Bolt Positions on Base Plates

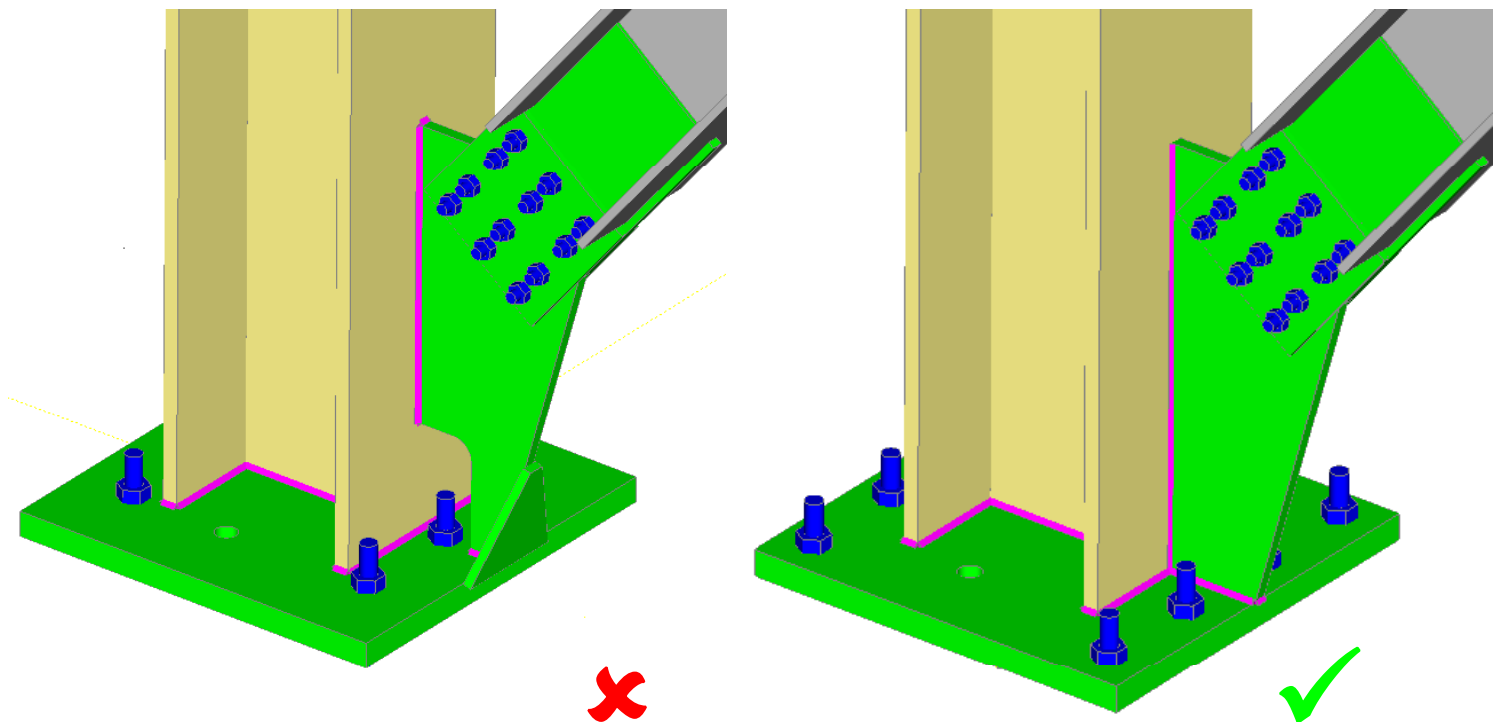
This problem occurs on many different types of projects and is a frustration to detailers and fabricators alike. The positioning of bolts on the centreline of base plates which clash with the bracings. It is caused by 2 dimensional thinking and not considering the bracing connections.

- The gusset plate requires notching around the holding down bolt meaning more fabrication and less effective weld area.
- Stiffening may be required at additional cost and looks unsightly.
- In some cases bolts are positioned too close to the column flanges can clash with the welds and restricts possible site modifications.

- Use 4 bolt base or 8 if necessary. Do not position bolts on the centreline of bases where a bracing is present.
- Take into account the distance from the flange to the centre of bolts allowing for the washers to fit without clashing with the welds. A good rule of thumb is 2 x bolt \varnothing minimum.
- Extra weld means a reduced weld stress and in turn a smaller weld size.
